P802.1Qdy - RSTP/MSTP YANG – Reusability across SDOs
Murugan Balraj (Nokia)
(murugan.balraj@nokia.com)

Introduction

P802.1Qdy decoupling proposal – MSTP YANG

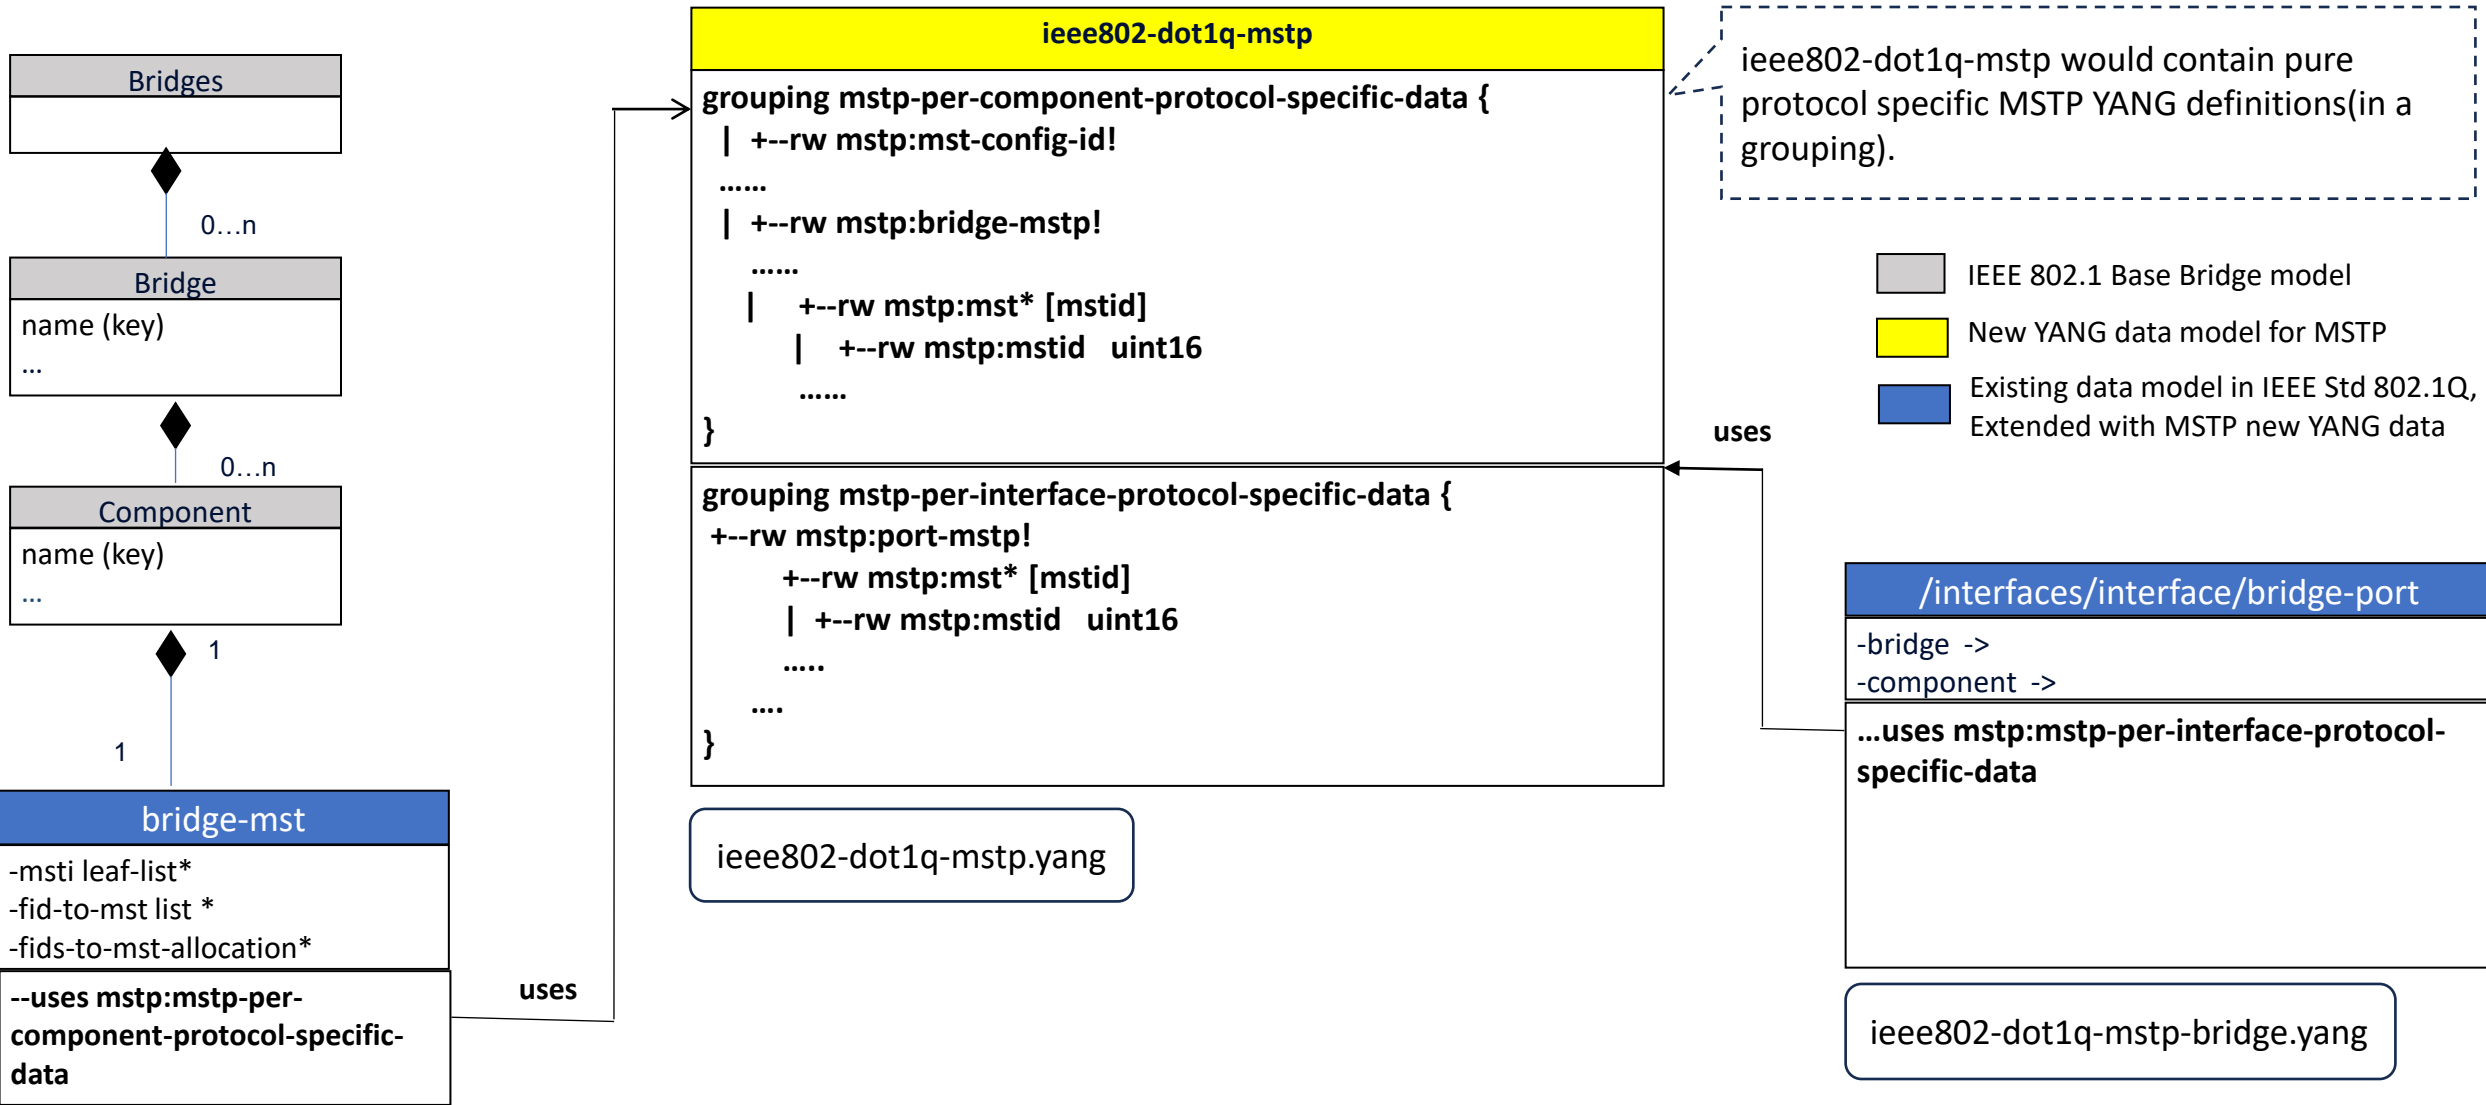
MSTP

IEEE 802.1Qdy current YANG definition

Per component MSTP augment

- ❖ YANG "Grouping" (mstp-per-component-protocol-specific-data) :
 - MSTP YANG configuration/state data which are per component specific.

Note : Only the **YANG** is restructured considering reusability. The resultant **YANG** tree/functionality is the same as that on page 20 of [802-1Qdy-d2-0.pdf](#)

P802.1Qdy decoupling proposal – RSTP YANG

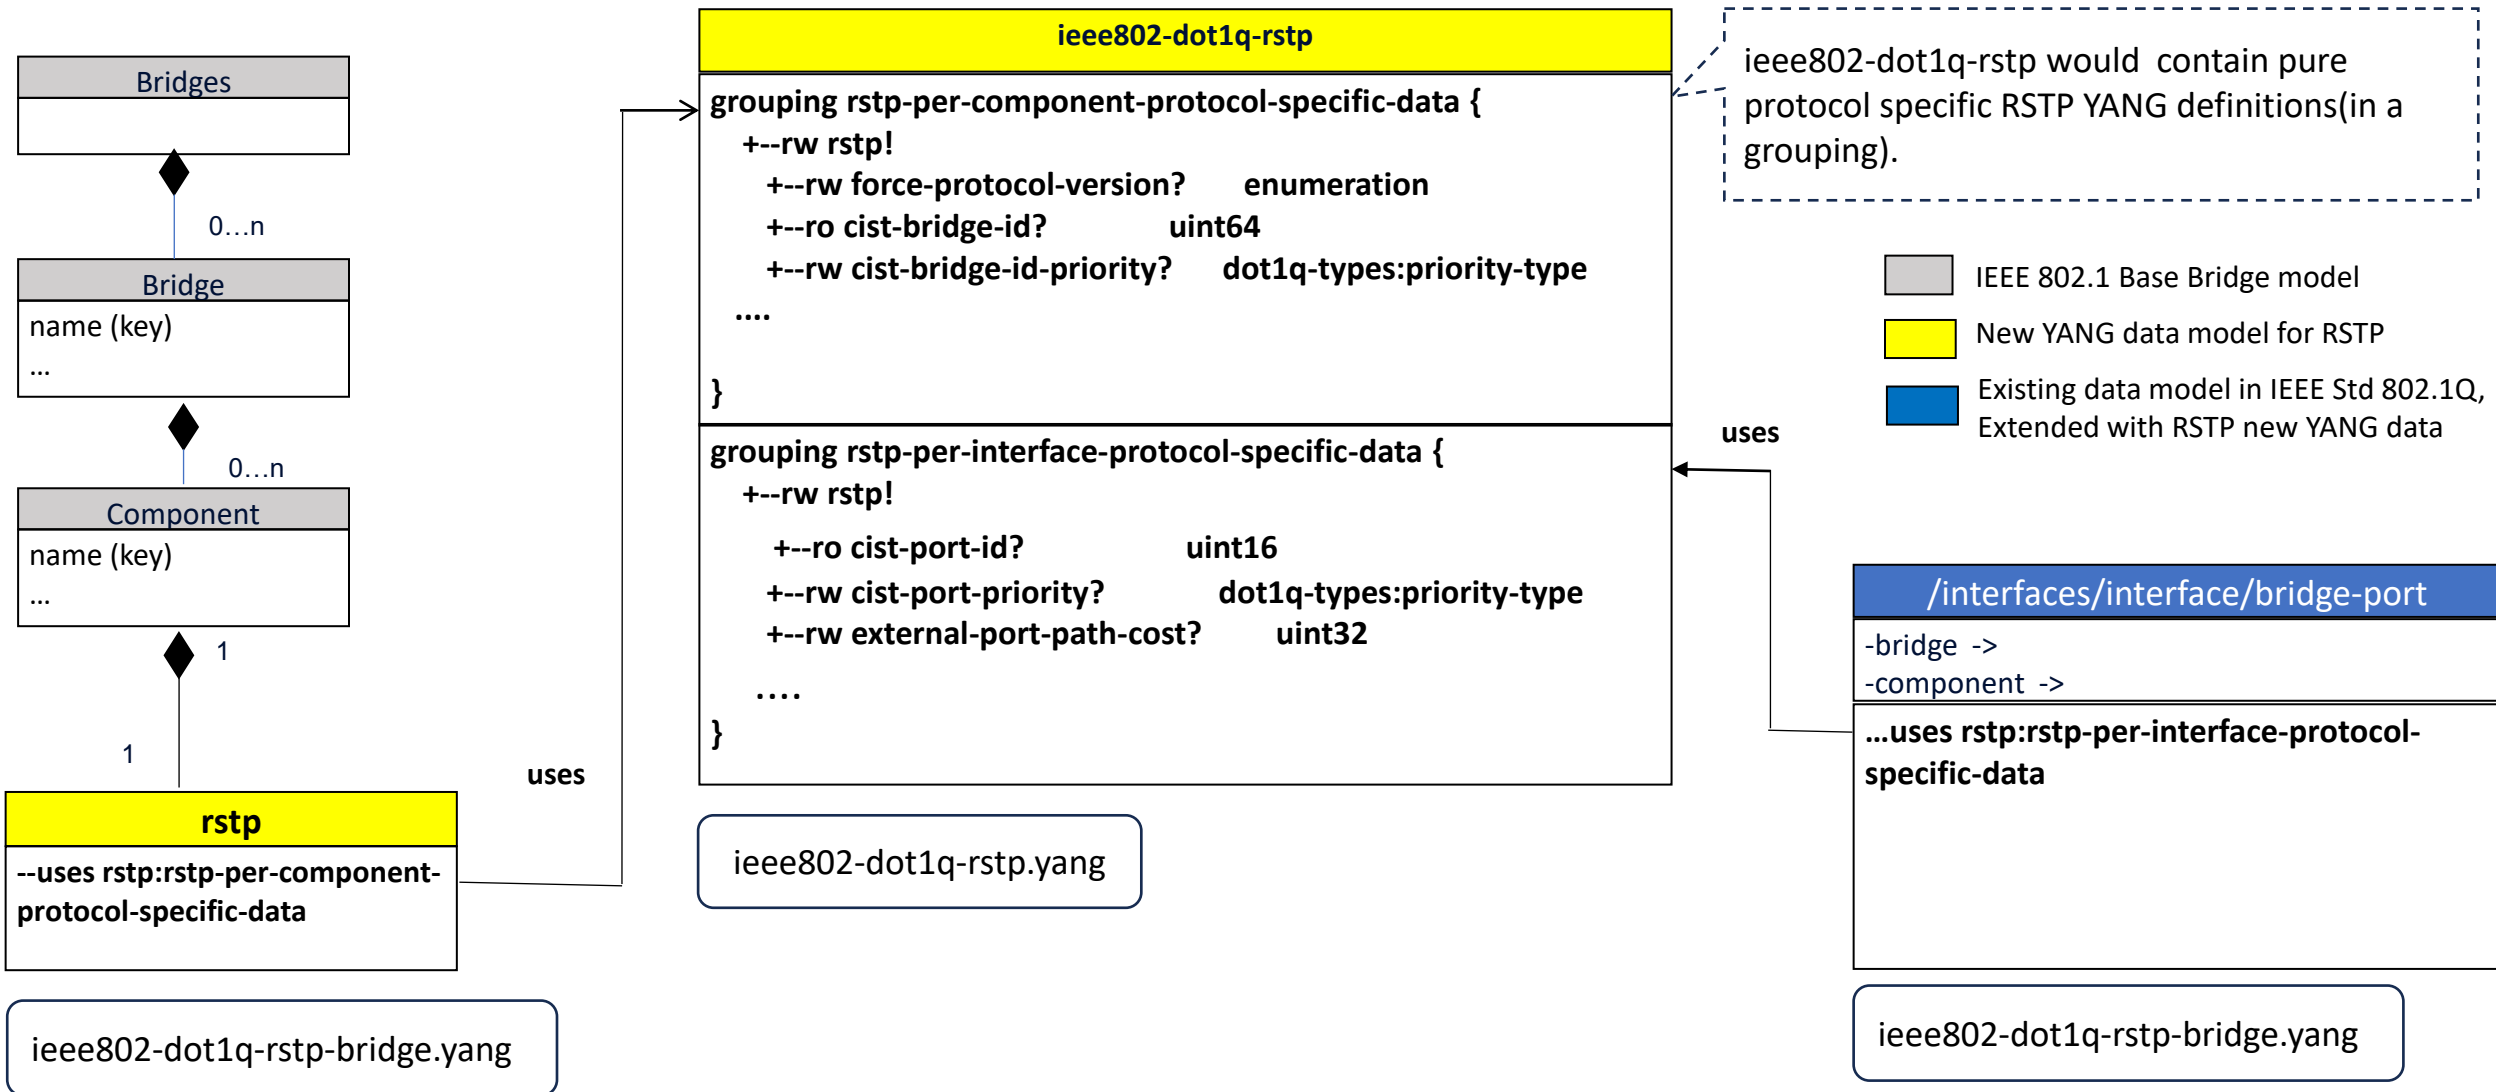
RSTP

IEEE 802.1Qdy current YANG definition

Per component RSTP augment

- ❖ YANG `"Grouping" (rstp-per-component-protocol-specific-data)` :
 - RSTP YANG configuration/state data which are per component specific.

Note : Only the YANG is restructured considering reusability. The resultant YANG tree/functionality is the same as that on page 19 of [802-1Qdy-d2-0.pdf](#).

Some observations on configuration/data consistency

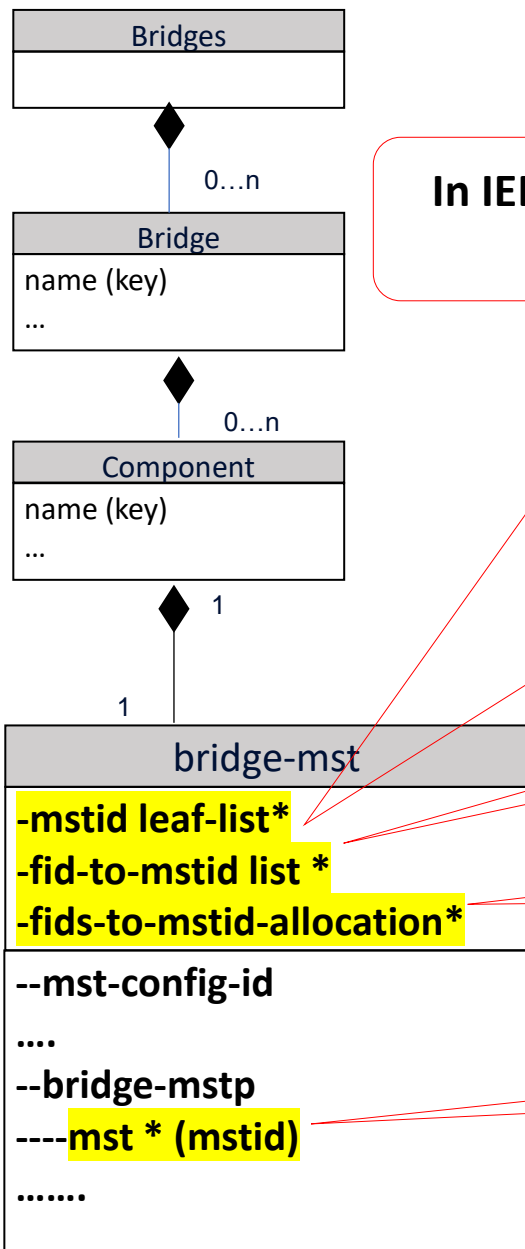
In IEEE P802.1Q-2022-REV , a container “bridge-mst” is defined with an object “mstid” which is a leaflist (/bridges/bridge/component/bridge-mst/mstid)

In IEEE P802.1Q-2022-REV, a container “bridge-mst” is defined which has a list “fid-to-mstid” that also has an object mstid /bridges/bridge/component/bridge-mst/fid-to-mstid/mstid

In IEEE P802.1Q-2022-REV, a container “bridge-mst” is defined which has a list “fid-to-mstid-allocation” that also has an object mstid /bridges/bridge/component/bridge-mst/fid-to-mstid-allocation/mstid

In P802.1Qdy, another list for the mst instance is introduced (/bridges/bridge/component/bridge-mst/bridge-mstp/mst)

Since all the above objects refer to the same MST Instance ID, there could be a different set of values in each of these lists

Some observations on configuration/data consistency

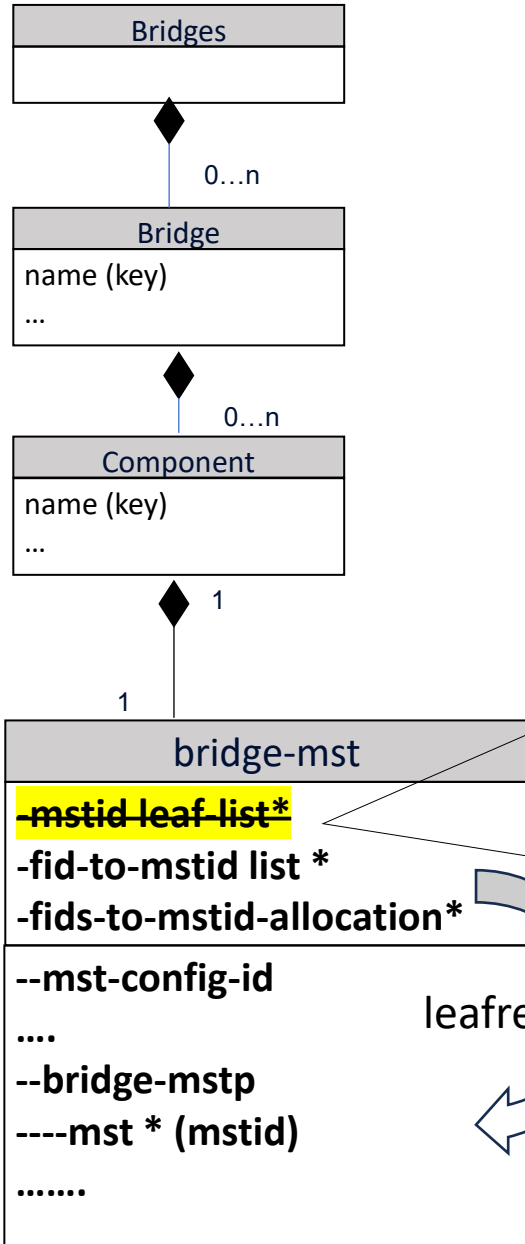
Avoiding inconsistent configuration and/or redundant data may require modifying the YANG objects specified in IEEE Std 802.1Q-2022 under “/bridges/bridge/component/bridge-mst”.

- Would it be acceptable to remove the “mstid” leaf-list from IEEE Std 802.1Q ?
- The list /bridges/bridge/component/bridge-mst/bridge-mstp/mst proposed as part of P802.1Qdy should be sufficient to configure the MST instances. This list would be the main list/configuration for the set of MST instances in each Bridge component.
- If there is a need to refer/specify the “mstid” anywhere else in the YANG tree, a “leafref” type could be used.
- E.g. In the two lists “fid-to-mstid” and “fid-to-mstid-allocation”, the definition of “leaf mstid” could be changed from “type dot1qtypes:mstid-type” to “type leafref”.
- Also, these two lists would need to be moved to the newly proposed IEEE 802.1 specific YANG module “ieee802-dot1q-mstp-bridge” (since these would need to be augmented to Bridge-component).

VLAN Bridge component and port nodes + RSTP nodes

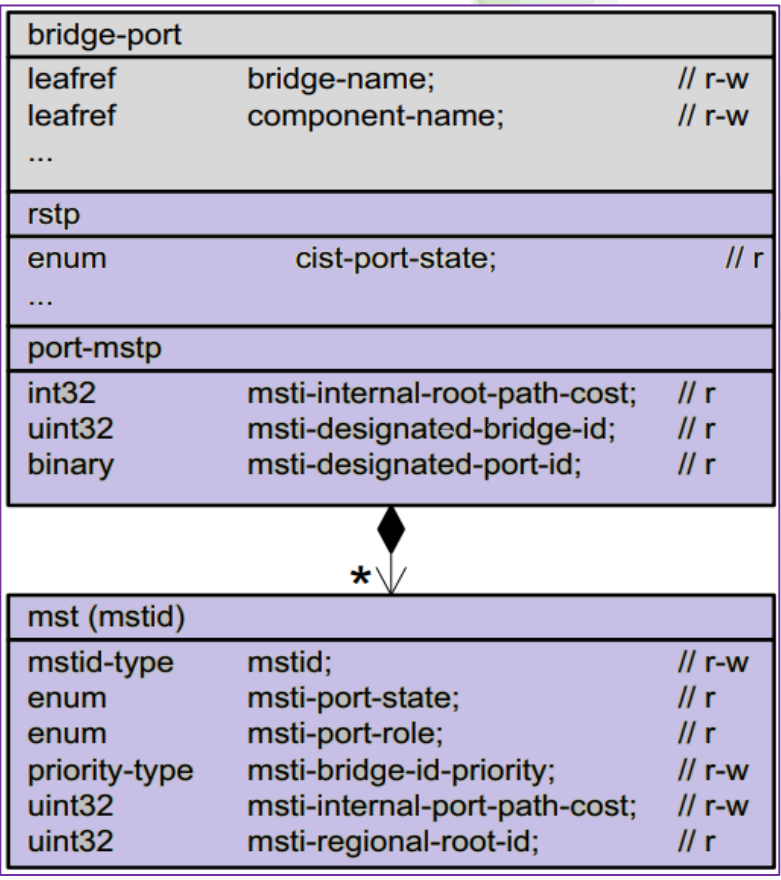
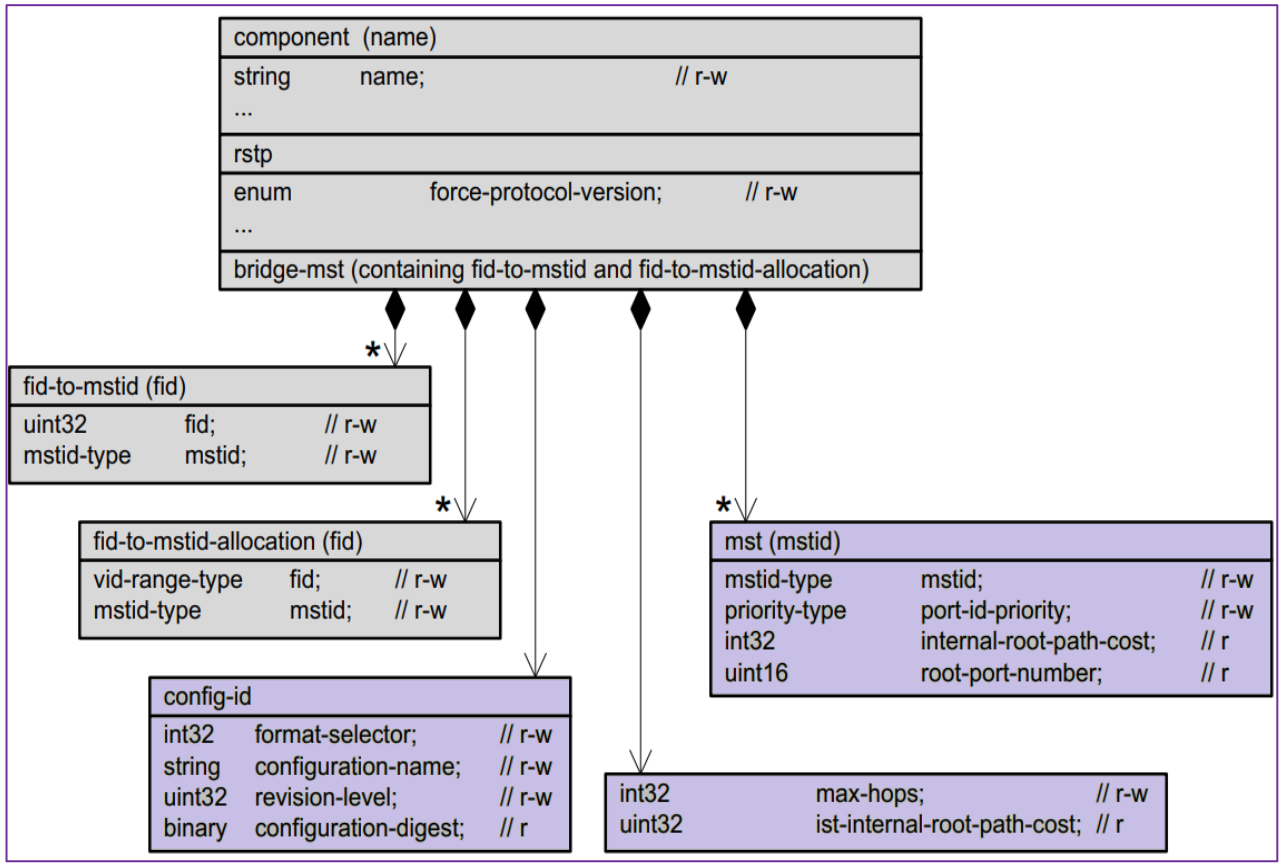
These RSTP protocol specific configuration and state data directly augment `"/bridges/bridge/component"`.
A non-IEEE 802.1 device cannot import this YANG module due to the direct augmentation.

These RSTP protocol specific interface configuration and state data directly augment `"/interface/interface/bridge-port"`.
A non-IEEE 802.1 device cannot import this YANG module due to the direct augmentation.
